FINAL DATA SUMMARY REPORT

Interim Data Collection Remedial Investigation and Feasibility Study

Centredale Manor Restoration Project Superfund Site North Providence, Rhode Island

**Comment Resolution: Final Data Summary Report
Centredale Manor Restoration Project Superfund Site
September 4, 2002**

Figure 2-1. Tailrace Soil Boring Locations

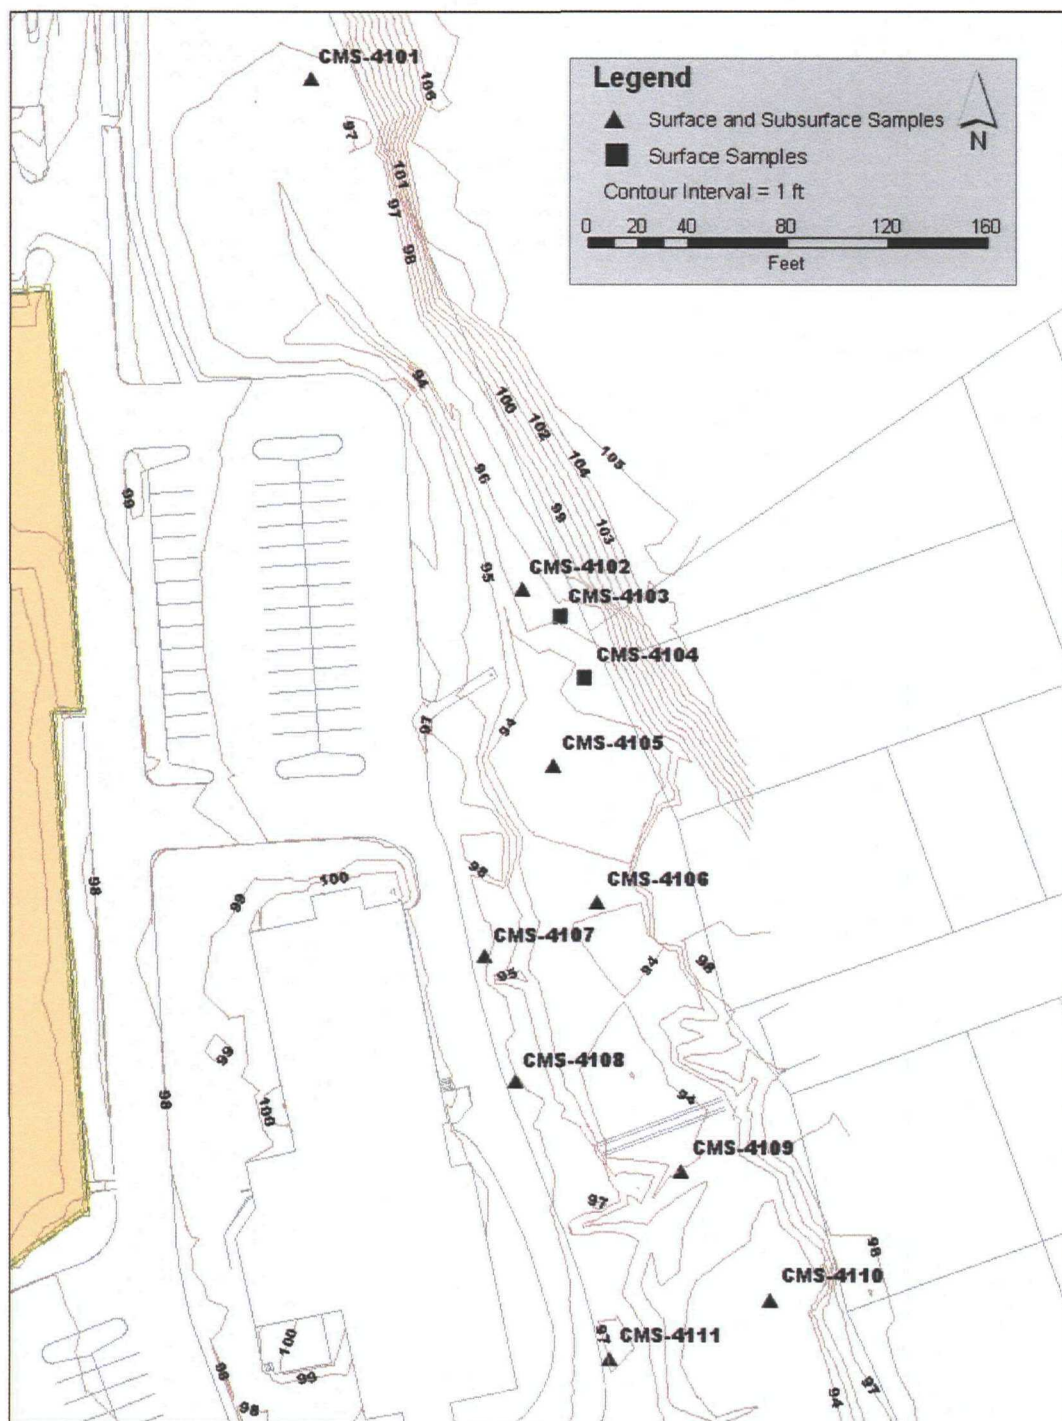
Comment #8 (RS) - Figure 2-1. Please label a few of the topographic contour lines, and add a note to state the contour interval.

Response: Figure 2-1 has been updated to include topographic contour line labels and a definition of the contour interval in the legend.

Figure 4-1 Cross Sections of Tailrace Soil Types

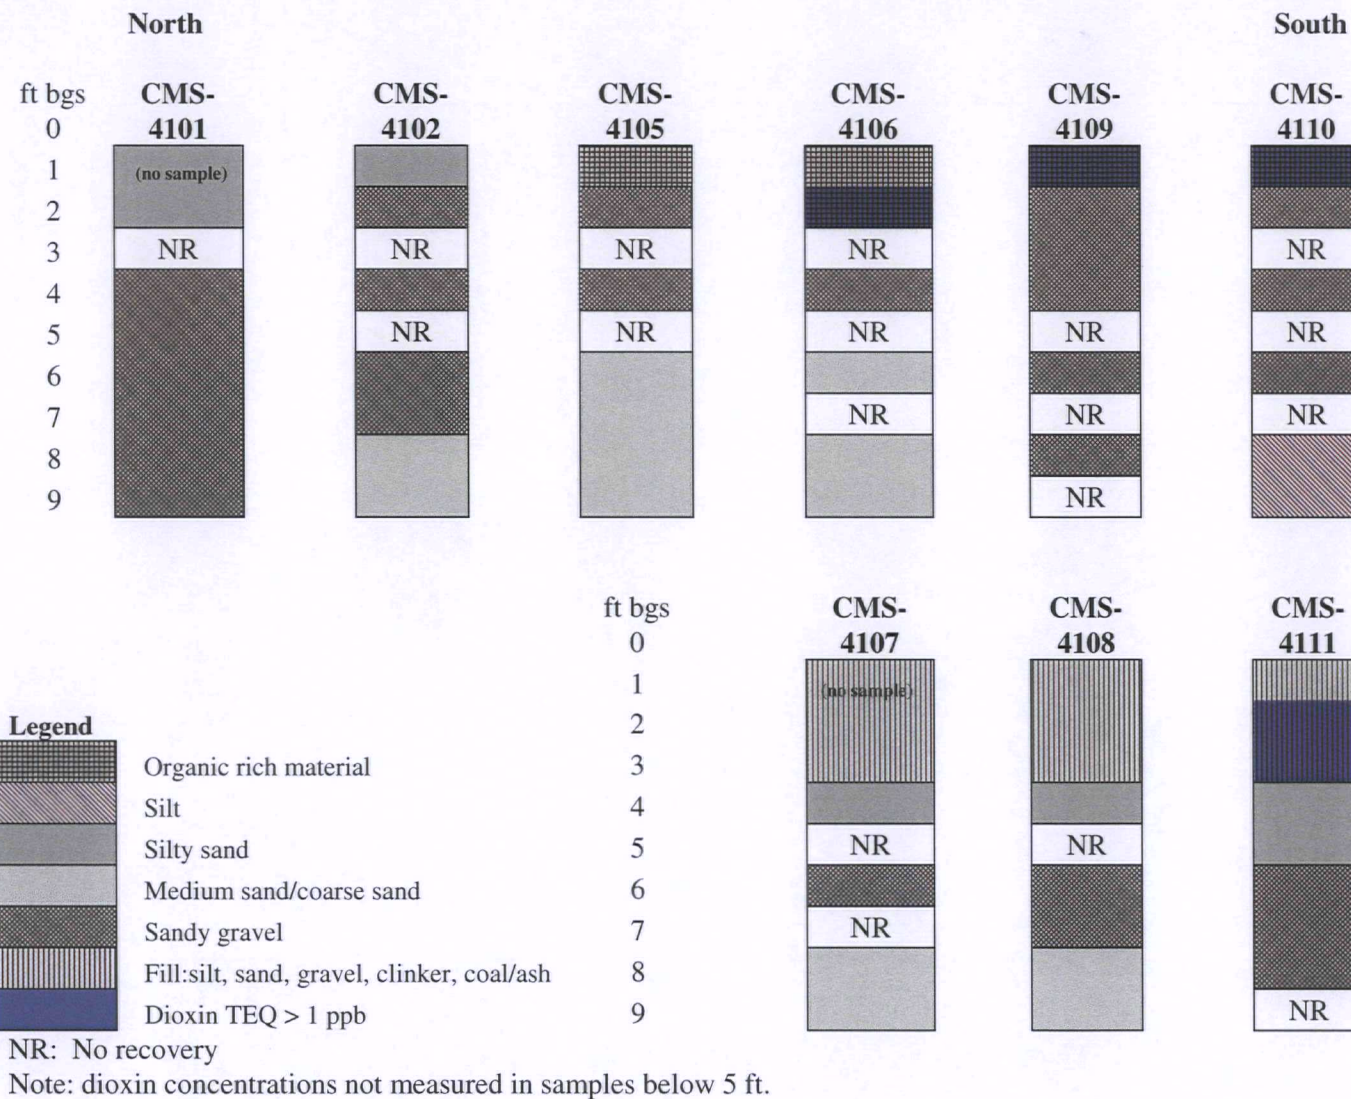
Comment #3 (RS) – Figure 4-1. Generally, the data on the distribution of contamination needs to be addressed in the tailrace design, to ensure limits of cap are sufficient, and determine actions where not delineated to closure on the east side (east of 01-DEL-100 and CMS-4104, and 01-DEL-300) and may extend onto private property, and on the west side, where contamination exists west of the fence (CMS-098 had 28 ppb dioxin at surface, CMS-4111 had 4 ppb 1 - 2.8 ft bgs). Will the EPA provide this report/data to LEA? When LEA's tailrace design is submitted, reviewers need to verify that cap limits are sufficient.

Response: This comment is noted.

Figure 4-3
Distribution of Tetrachloroethene (PCE)
in Groundwater Samples

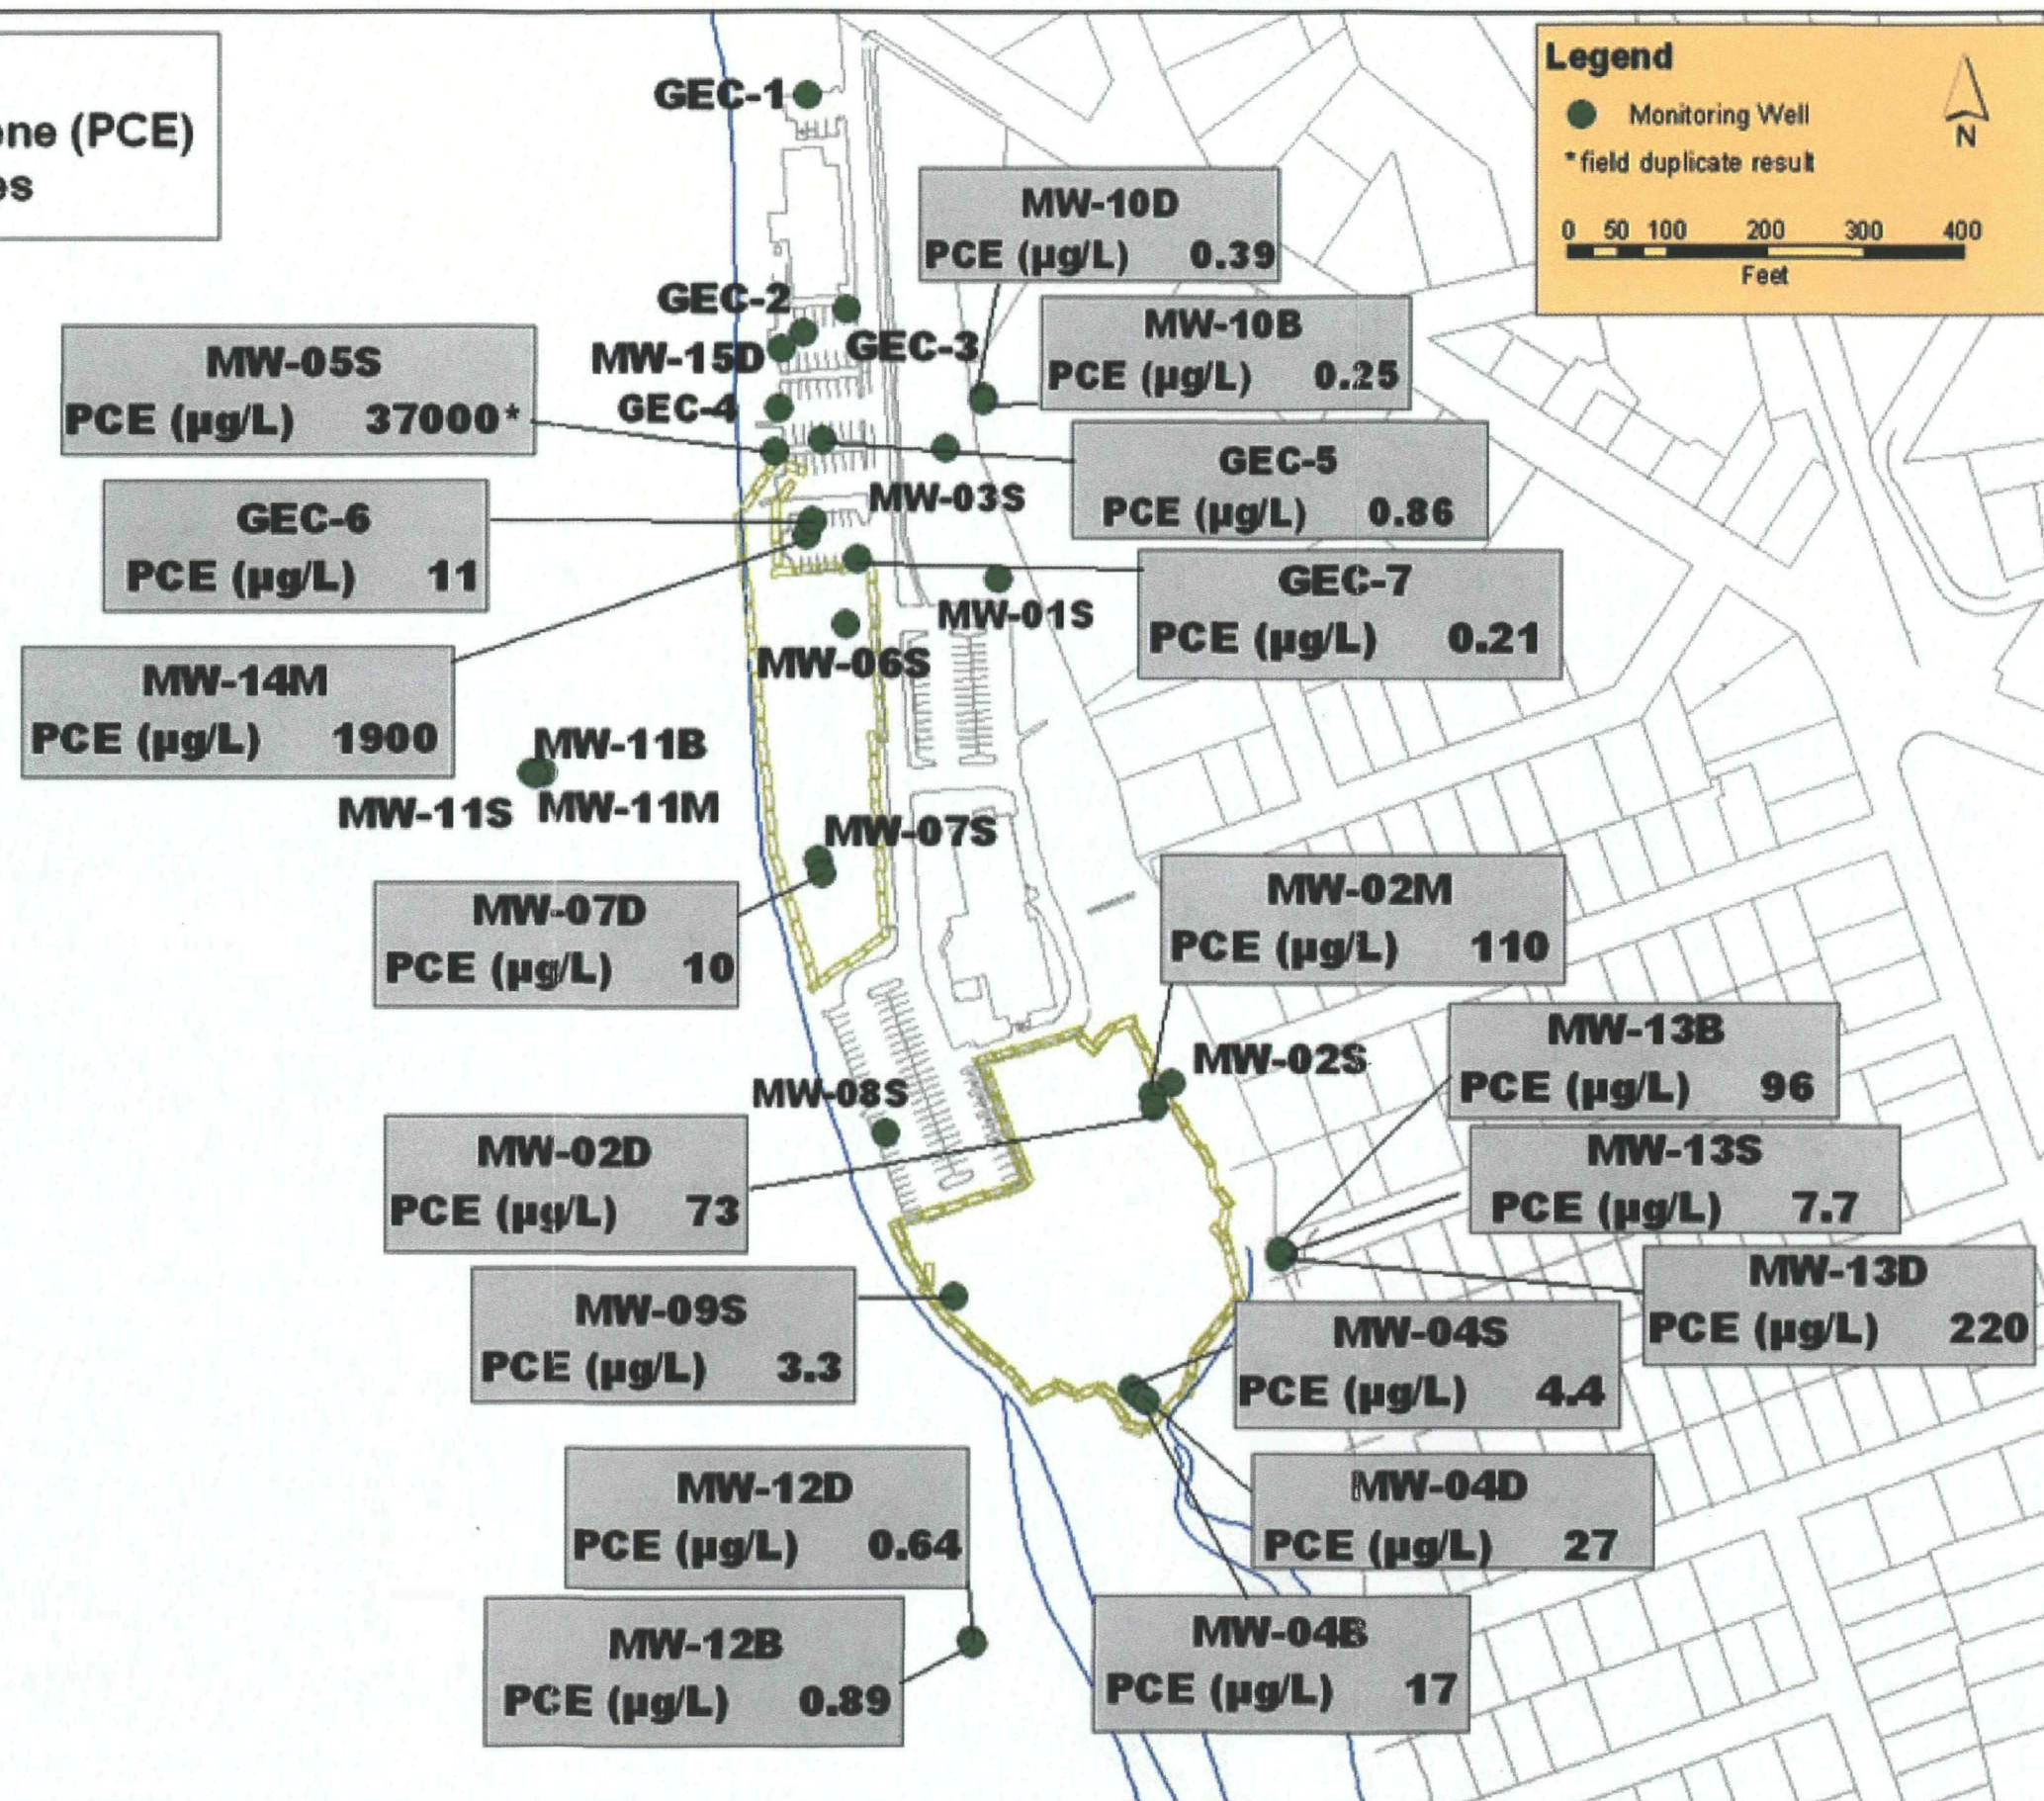
Comment #5 (RS) - pg4-2/sctn 4.2 Groundwater. Recommend adding a figure showing PCE concentrations at the various wells.

Response: A new figure (Figure 4-3) has been prepared that shows PCE concentrations detected in 2002 groundwater samples.
